RECEIPT DATE: 9-25-17 **ONSITE SEWAGE DISPOSAL SYSTEM**

OSDS Plan
2039 Terrapin Creek Road
Terrapin Creek, Lot 15
Woodstock, MD 21163

The OSDS Plan for Terrapin Creek, Lot 15 has been reviewed with the following comments:

ON SITE SEWAGE DISPOSAL SYSTEM DESIGN PLAN

- 2nd REPLACEMENT
- APPLICATION RATE = 0.8 GPD / sq.ft.
- DESIGN FLOW: 150 GPD X 4 BEDROOMS = 600 GPD
- 600 GPD / 0.8 GPD/sq.ft. = 750 sq.ft.
- 750 sq.ft. / 3 ft. WIDE TRENCH = 250 LF TRENCH
- 250 LF TRENCH X 0.56 REDUCTION CREDIT = 140 LF TRENCH

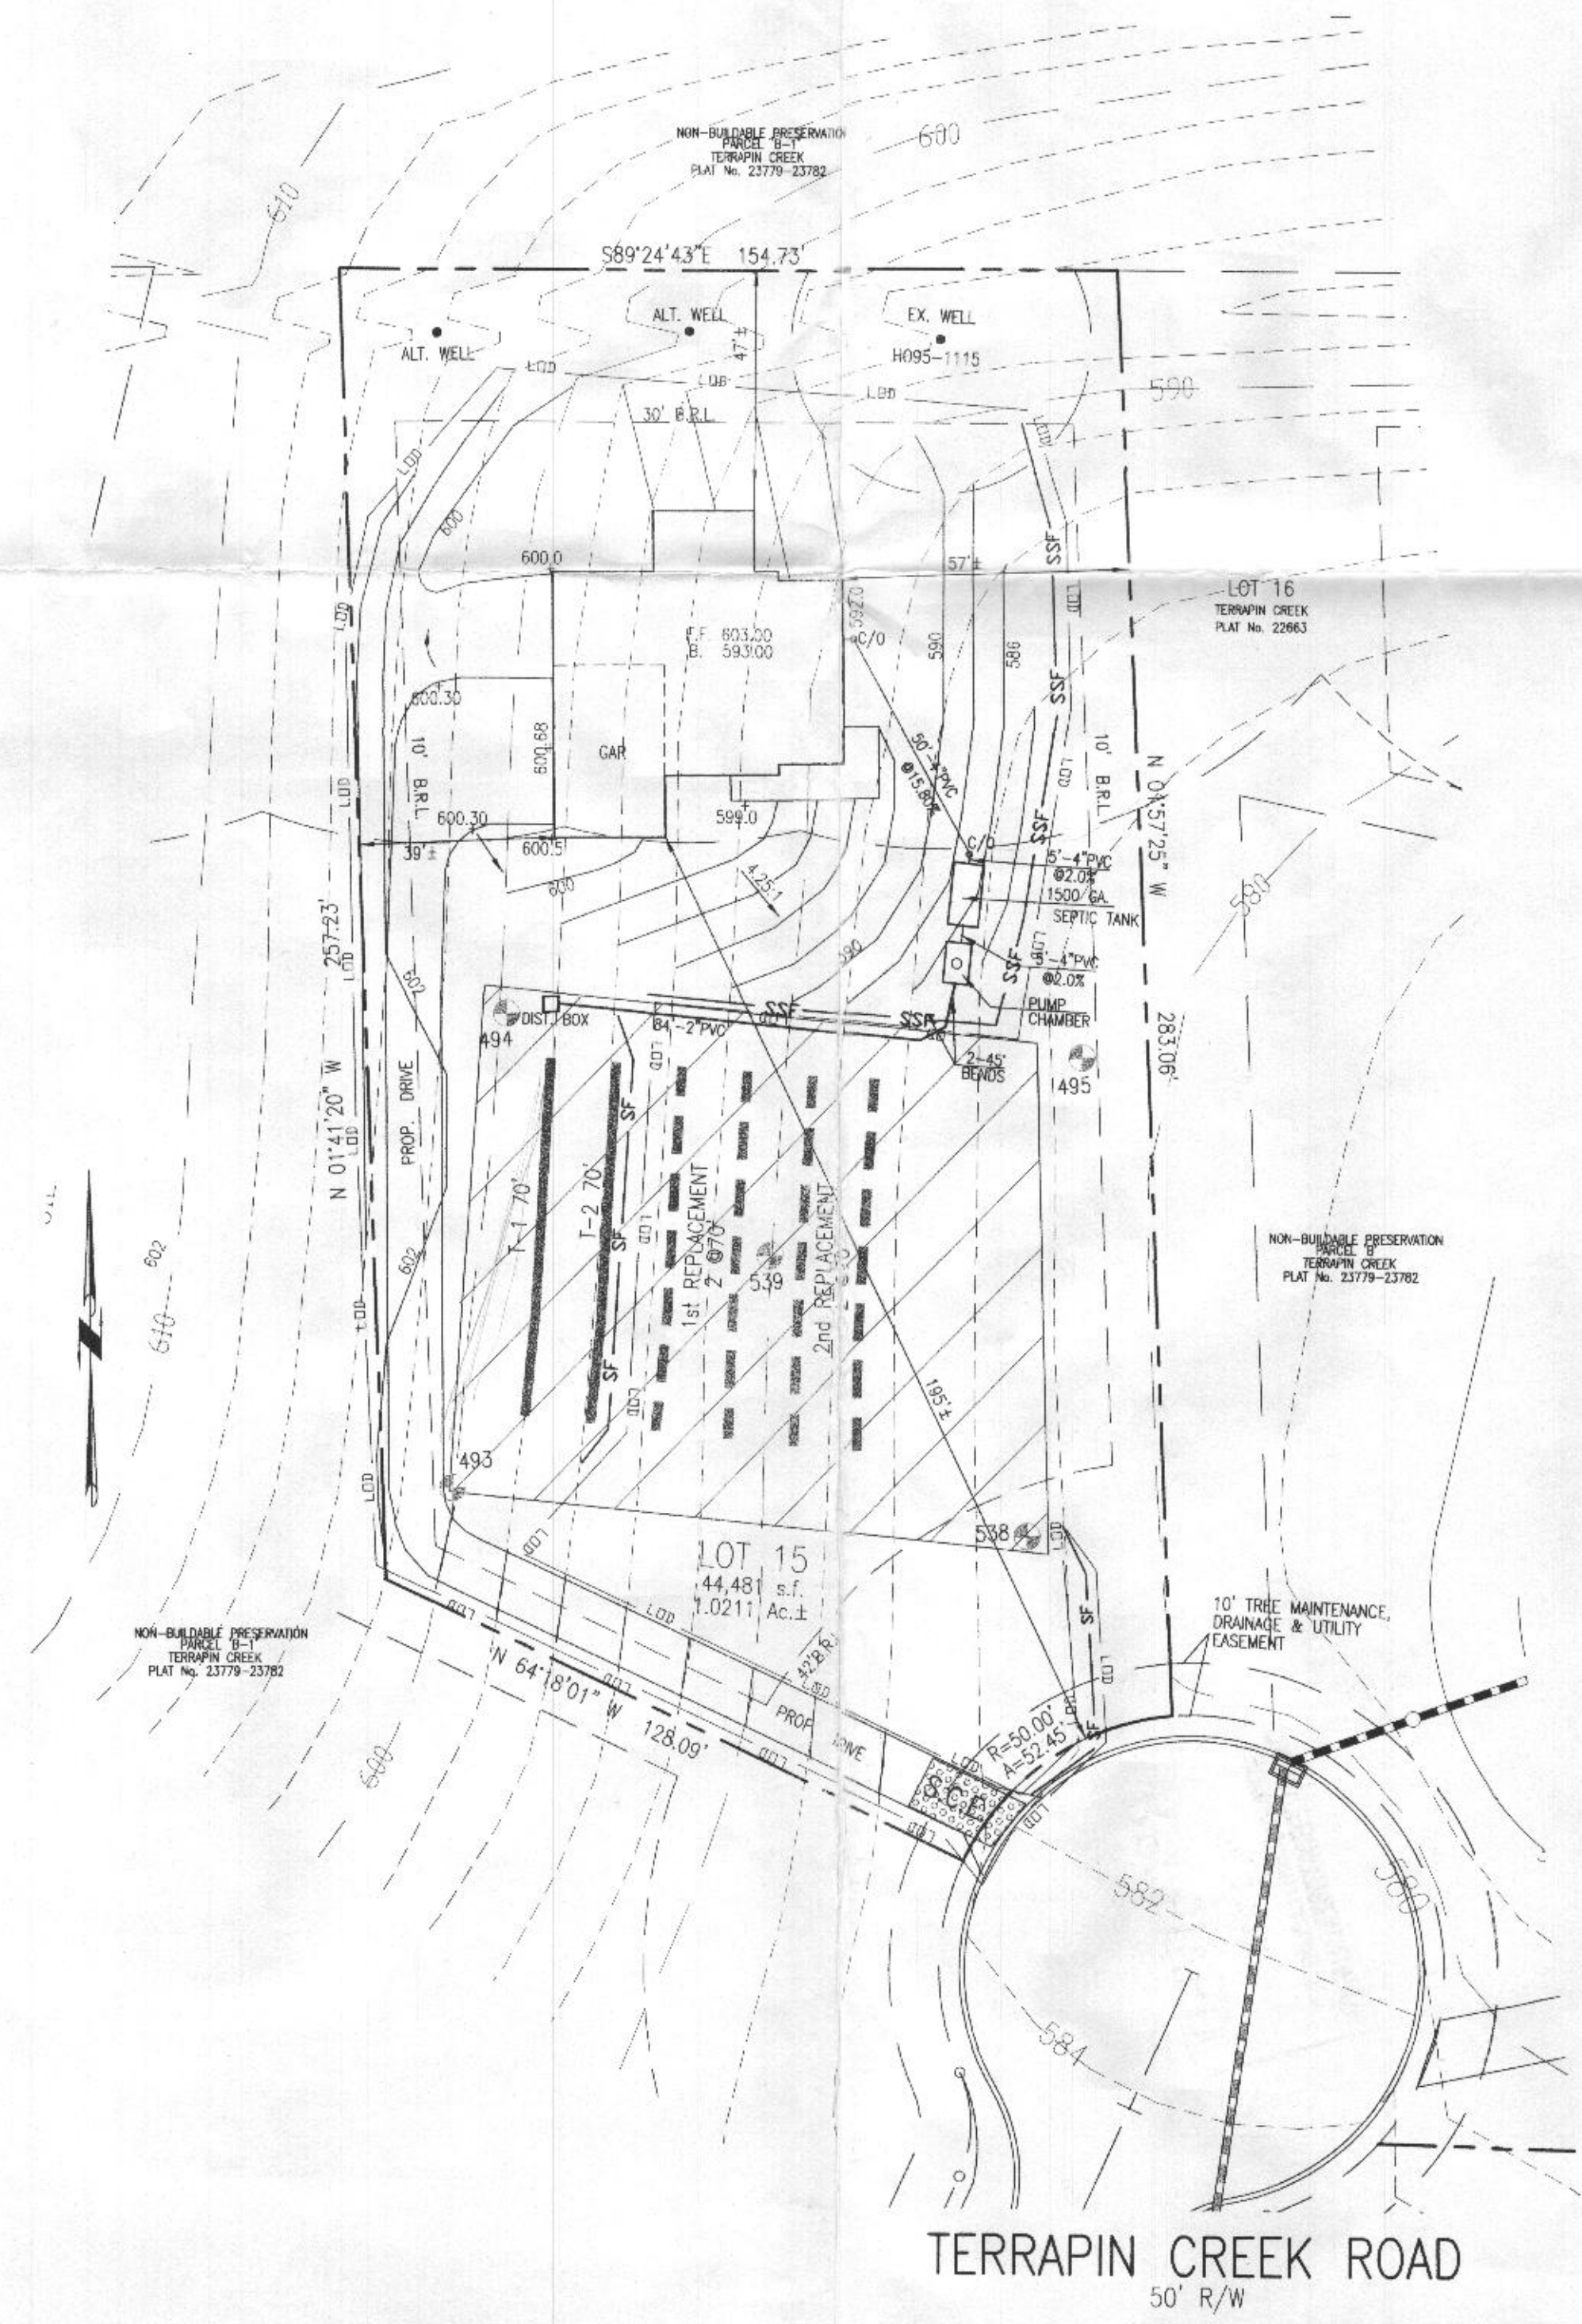
1. The friction loss should be more like 2.05 (per sand mound chart)

2. The TDH would be more like 19.69 (use 20).

3. TDH of 20 intersects the pump curve at 35 GPM.

4. Pump should be 1 / 3 HP, WE03.

5. Pump runtime = 3 minutes.

6. Change wording in calculation to 2nd replacement.

7. House detail elevations do not match layout elevations on plan.

8. *Move d-box inside SDA.*

Response 1: The computations were revised per the sand mound chart using a 3 minute run time (33.3 GPM). This provides a 1.85 factor for a friction loss of 2.39.

Response 2: The TDH is 20.03 (used 20).

Response 3: Pump curve intersection corrected to maximum 35 GPM.

Response 4: Pump corrected to 1 / 3 WE03M.

Response 5: Pump runtime revised to 3 minutes.

Response 6: Wording revised to 2nd replacement.

Response 7: House detail elevations corrected.

Response 8: d-box moved inside SDA.
